DRAWING TITLE		
BASEMENT B2 PLAN		
SCALE	DRAWN BY	PLOT DATE
1:100 @ A1	SG / AW	19/01/2022
PROJECT NO.	DRAWING NO.	REVISION
1511	DA-02	H

PROJECT
MIXED-USE DEVELOPMENT
321 - 331 CONDOMINE STREET
MANLY VALE NSW 2093
LOTS 20, 21, 22 & 25 on DP 11320
LOT 123 on DP 737259

Plans approved by the Land and Environment Court of NSW
PROCEEDINGS NO: 2021/266483
DATED: 11 February 2022

REVISIONS
BASEMENT B1 PLAN

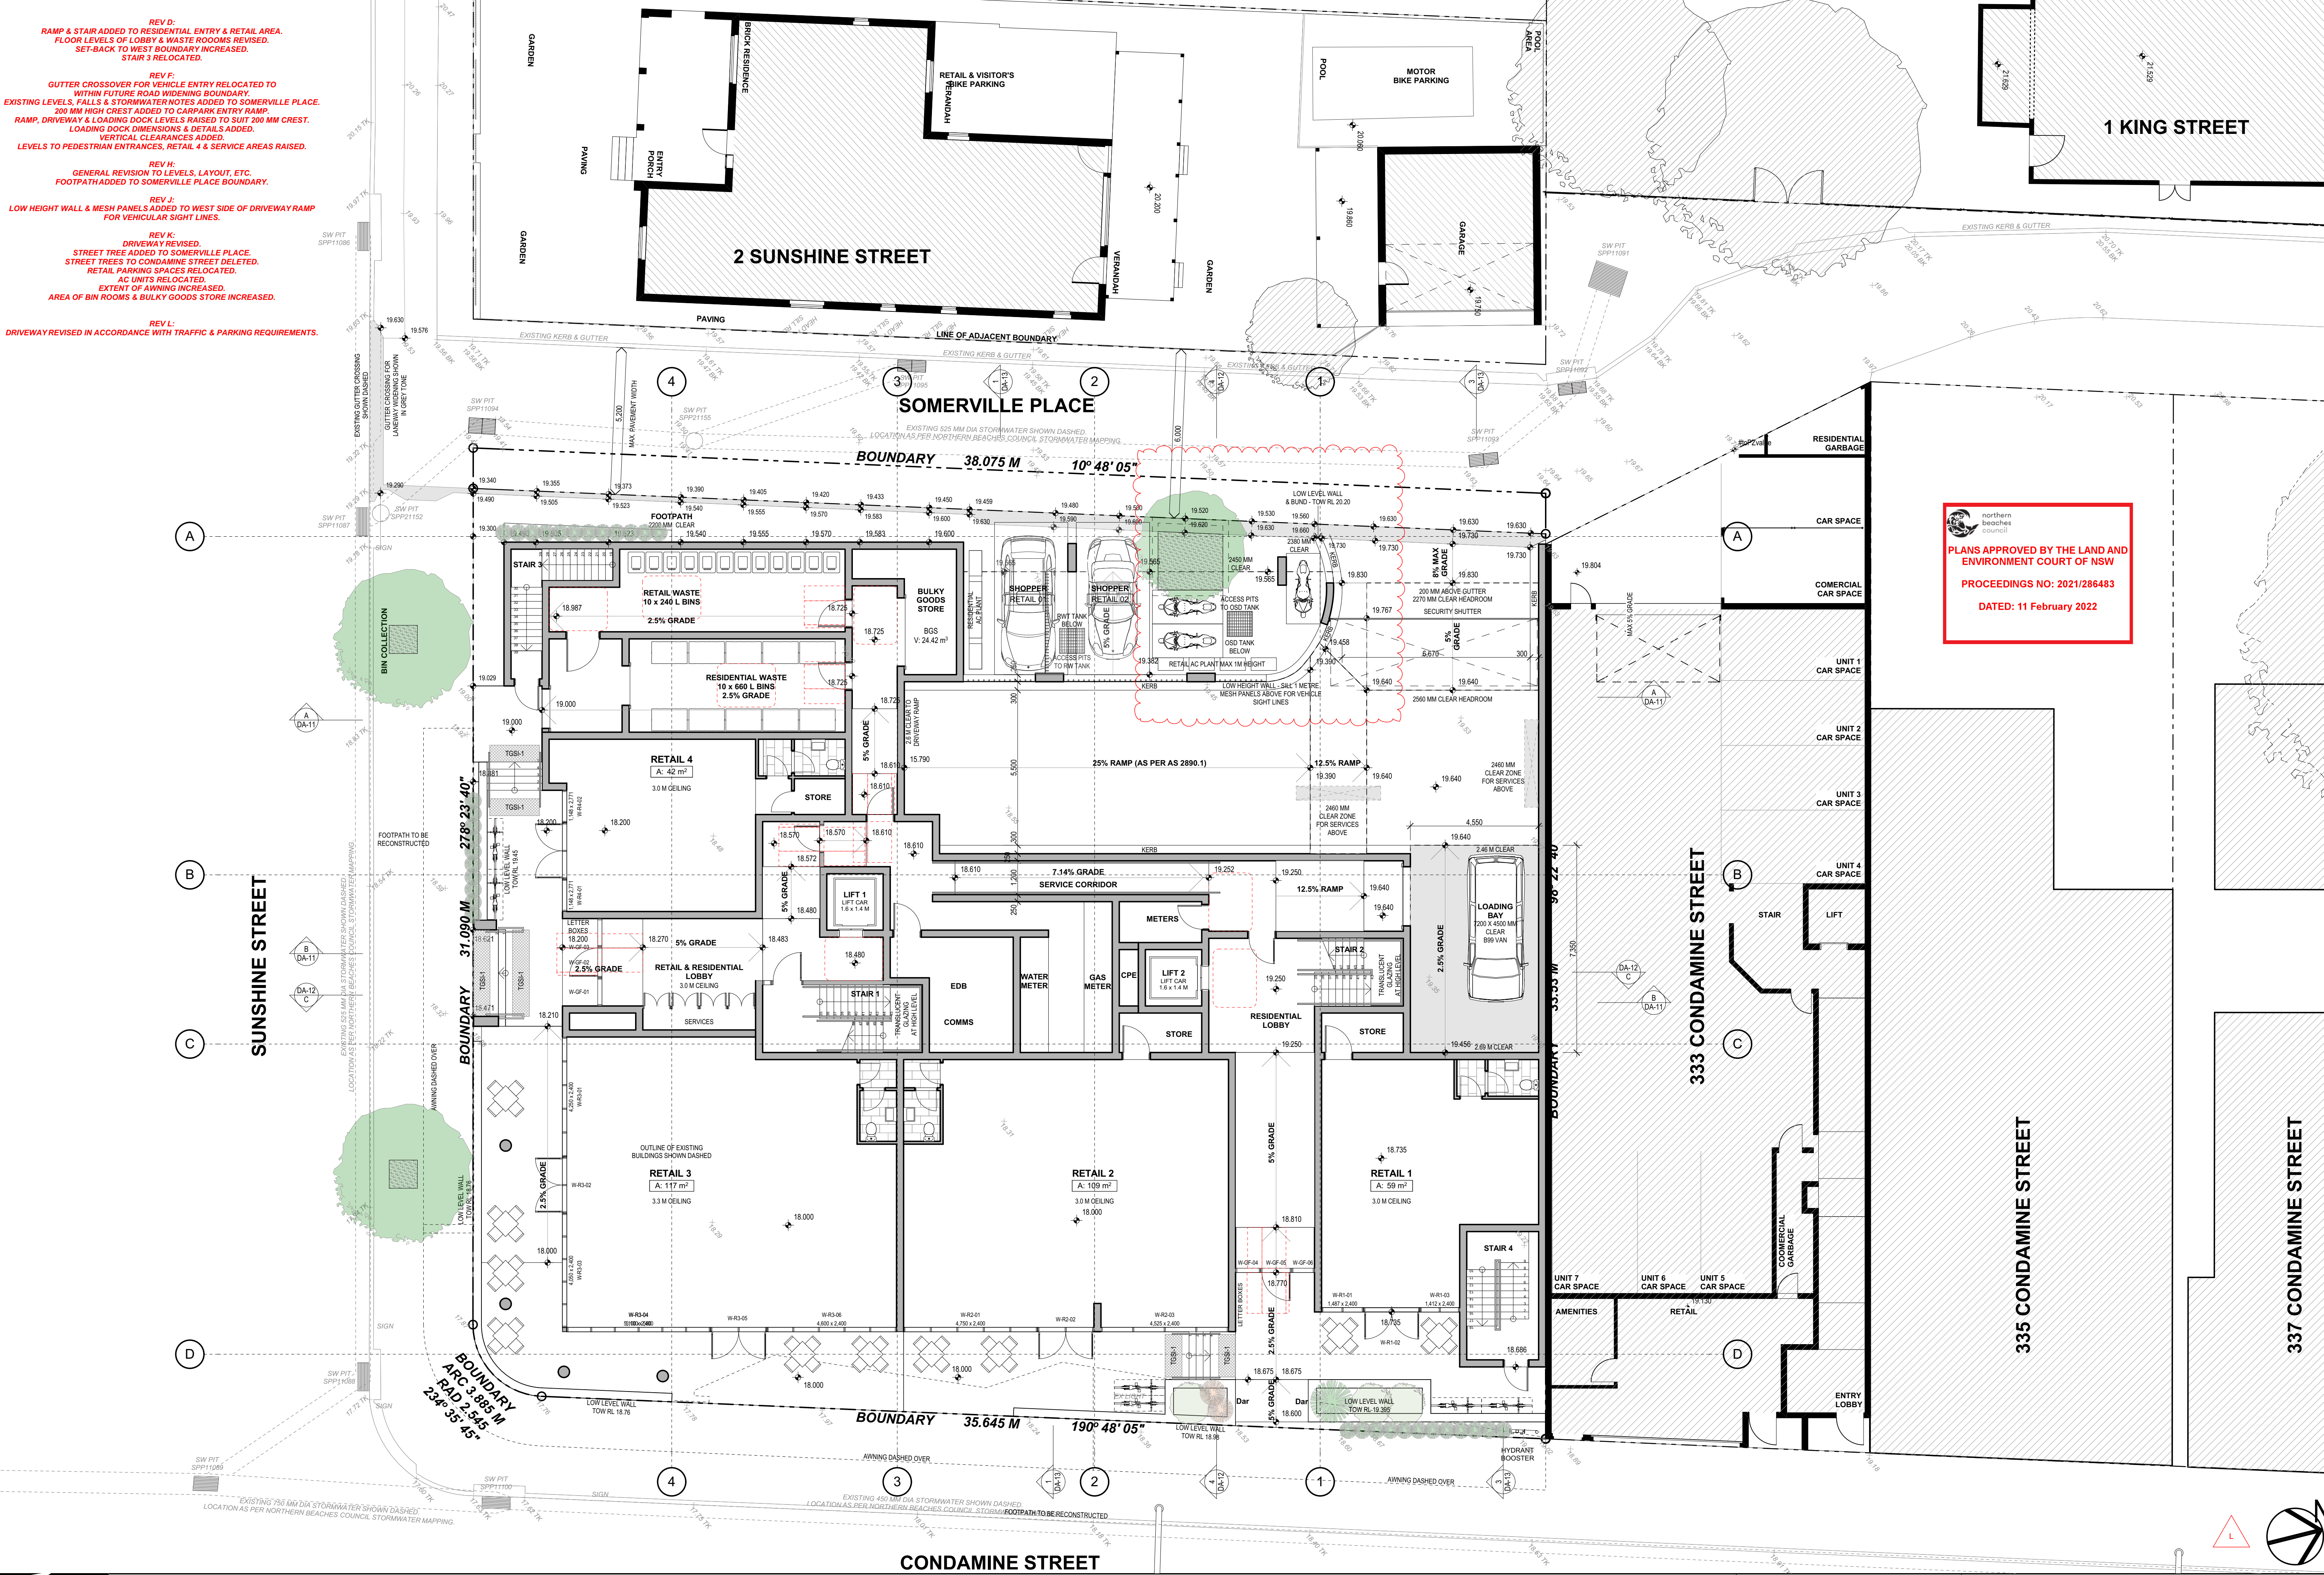
REV D:
RAMP & STAIR ADDED TO RESIDENTIAL ENTRY & RETAIL AREA.
FLOOR LEVELS OF LOBBY & WASTE ROOMS REVISED.
SET-BACK TO WEST BOUNDARY INCREASED.
STAIR 3 RELOCATED.

REV F:
GUTTER CROSSOVER FOR VEHICLE ENTRY RELOCATED TO
WITHIN FUTURE ROAD WIDENING BOUNDARY.
EXISTING LEVELS, FALLS & STORMWATER NOTES ADDED TO SOMERVILLE PLACE.
200 MM HIGH CREST ADDED TO CARPARK ENTRY RAMP.
RAMP, DRIVEWAY & LOADING DOCK LEVELS RAISED TO SUIT 200 MM CREST.
LOADING DOCK DIMENSIONS & DETAILS ADDED.
VERTICAL CLEARANCES ADDED.
LEVELS TO PEDESTRIAN ENTRANCES, RETAIL 4 & SERVICE AREAS RAISED.

REV H:
GENERAL REVISION TO LEVELS, LAYOUT, ETC.
FOOTPATH ADDED TO SOMERVILLE PLACE BOUNDARY.

REV J:
LOW HEIGHT WALL & MESH PANELS ADDED TO WEST SIDE OF DRIVEWAY RAMP
FOR VEHICULAR SIGHT LINES.

REV K:
DRIVEWAY REVISED.
STREET TREE ADDED TO SOMERVILLE PLACE.
STREET TREES TO CONDOMINE STREET DELETED.
RETAIL PARKING SPACES RELOCATED.
AC UNITS RELOCATED.
EXTENT OF AWNING INCREASED.
AREA OF BIN ROOMS & BULKY GOODS STORE INCREASED.

REV L:
DRIVEWAY REVISED IN ACCORDANCE WITH TRAFFIC & PARKING REQUIREMENTS.

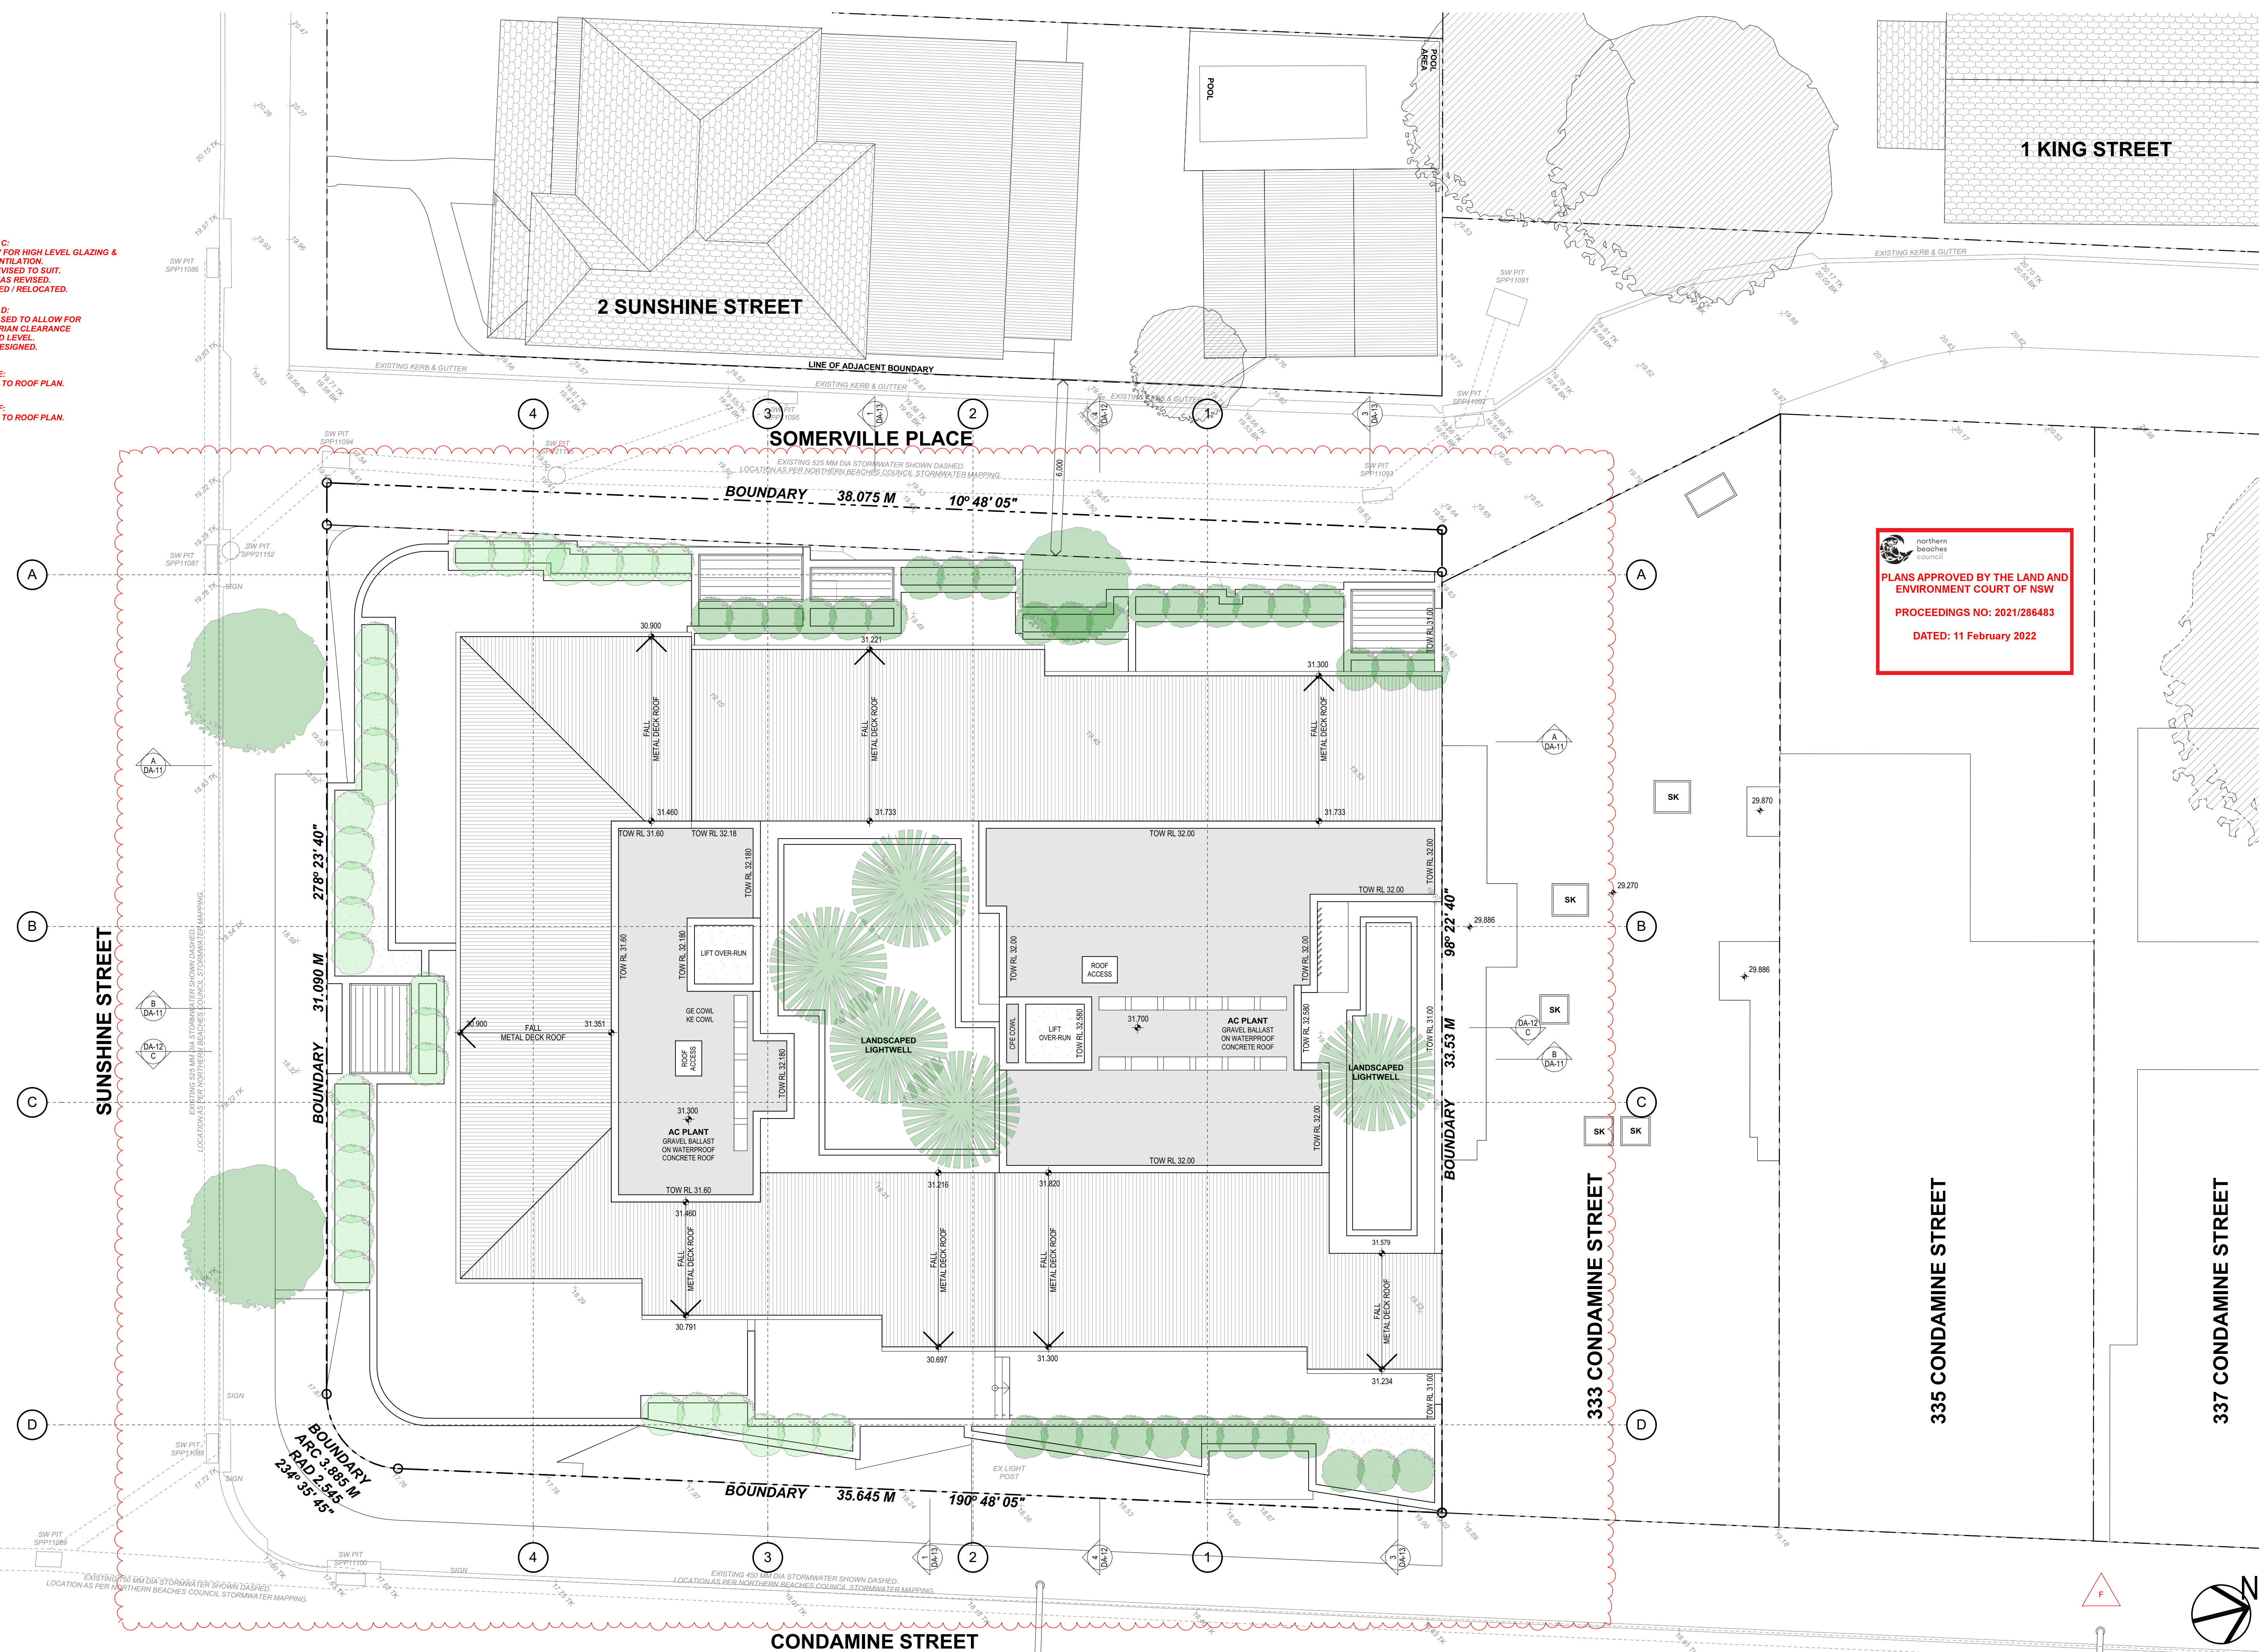
REV C:
ROOF RE-DESIGNED TO ALLOW FOR HIGH LEVEL GLAZING &
NATURAL VENTILATION.
ROOF LEVELS REVISED TO SUIT.
AC PLANT AREAS REVISED.
SKYLIGHTS DELETED / RELOCATED.

REV D:
ROOF LEVELS INCREASED TO ALLOW FOR
VEHICLE & PEDESTRIAN CLEARANCE
AT GROUND LEVEL.
ROOF RE-DESIGNED.

REV E:
GENERAL REVISION TO ROOF PLAN.

REV F:
GENERAL REVISION TO ROOF PLAN.
